Reply to Referee 1:

The article focuses on studying the interactions between hydrological processes involving karst aquifers, conduits, and streams, varying with precipitation and other factors that are later described in detail. The work is well-structured, the figures are of good quality, and the reading is fairly smooth.

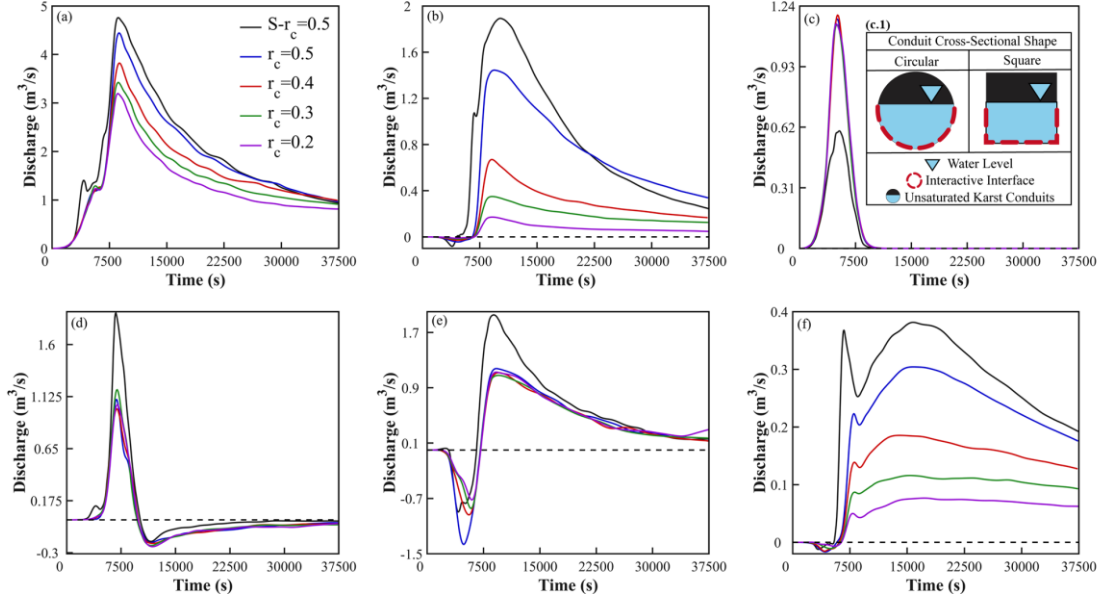
(2) The analytical and numerical approach is based on a representative sample of an aquifer, with the conduit size set by the authors (which I also find quite large) and a variation in rainfall intensity that I do not understand, as it is measured in meters according to Table 1. In hydrology, rainfall intensity is measured in mm/h, representing the amount of rainfall per unit of time. I kindly ask the authors to better define this aspect and, if necessary, correct it.

- Rationality of conduit dimensions: We have added a parameter sensitivity analysis (Lines 816-855), which quantifies the impact of different conduit diameters (0.2–0.5 m) and cross-sectional shapes (circular/square) on fluxes between media components using Fig. 12. This validates the physical basis for the parameter settings.
- Correction of precipitation intensity unit: The entry “Precipitation intensity (m)” in Table 1 was a typographical error; we have deleted this column. Furthermore, detailed definitions of the precipitation function have been added in the “2.5 Rainfall Infiltration Recharge

Fig. 12 presents hydrographs under conditions of circular conduits with varying radii ($r=0.2, 0.3, 0.3$, and 0.5 m) and square-section conduits ($r=0.5$ m) for (a) stream-connected flow, (b) karst spring discharge, (c) epikarst flow, (d) porous medium I (PM I), (e) PM II, and (f) PM III. Fig. 12(c.1) illustrates different conduit cross-sectional shapes to analyze their impacts on the interactive flow between karst aquifer systems and adjacent streams.

As shown in Fig. 12(a), larger conduit radii correspond to higher initial discharge peaks and shorter peak arrival times, indicating enhanced porous medium recharge and faster fluid transmission through larger conduits. Notably, the square-section conduit ($s-r_c=0.5$) exhibits higher peak discharge than its circular counterpart ($r_c=0.5$) due to its surplus cross-sectional area accommodating greater fluid discharge under identical nominal radii.

Fig. 12(b) demonstrates that karst spring peak discharge increases with conduit radius. At $r=0.5$ m, the square-section conduit ($s-r_c=0.5$) achieves higher peak discharge than the circular conduit ($r_c=0.5$), but displays lower recession flow. This occurs because identical precipitation infiltration recharge leads to greater porous medium storage depletion during peak periods in square conduits, subsequently reducing porous medium-to-conduit recharge during baseflow recession.

Combined analysis of Figs. 12(c), (d), and (e) reveals that conduit radius variations do not significantly affect epikarst hydrographs or PM I/II hydrographs. However, square-section sinkholes modify flow patterns: epikarst hydrographs show lower values under square conduits, while PM I/II hydrographs exhibit higher values due to enhanced epikarst groundwater collection in square cross-sections, increasing recharge to PM I/II.

Fig. 12(e) indicates that larger conduit radii correspond to lower negative values. Combined with Fig. 12(a), this demonstrates that increased stream recharge through larger conduits elevates both stream peak discharge and water levels, thereby enhancing porous medium-stream interactions. Similarly, Fig. 12(f) shows that larger conduit radii increase karst spring discharge and PM III hydrograph elevation through enhanced gravity-driven groundwater recharge.

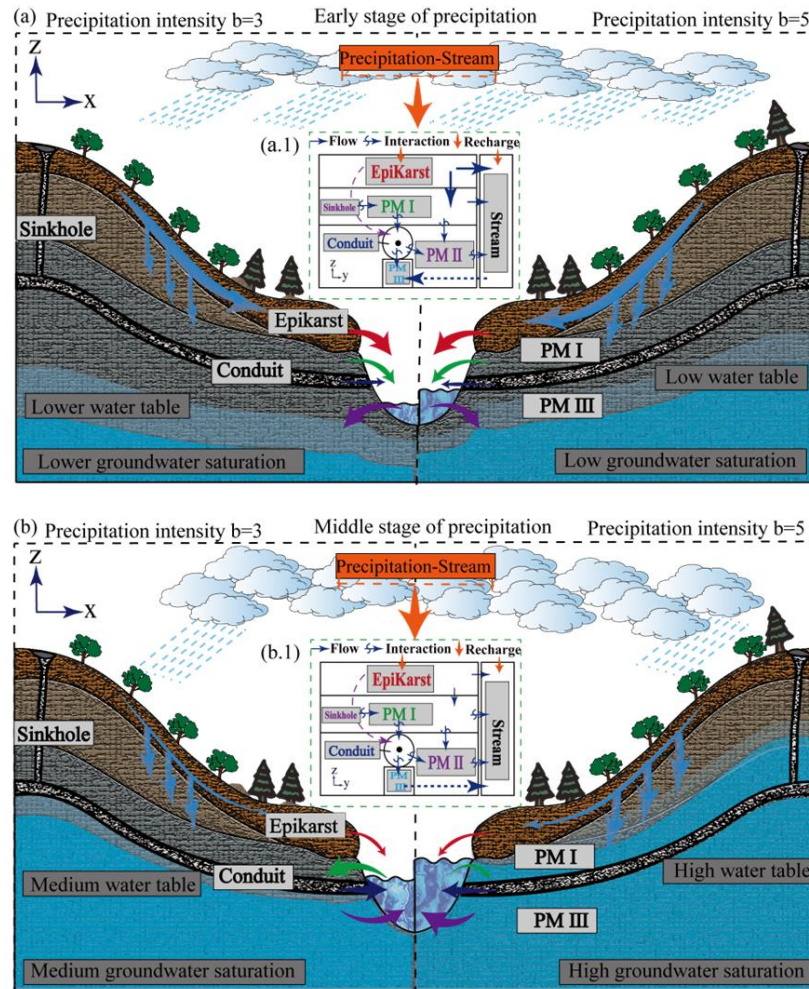
(6) Figure 1: insert letters a and b also in the figure for better readability

Thank you for the suggestion. We have clearly labeled subplots (a), (b), (a.1), and (b.1) in Fig. 1 and updated the captions (Lines 1200–1207) to enhance readability.
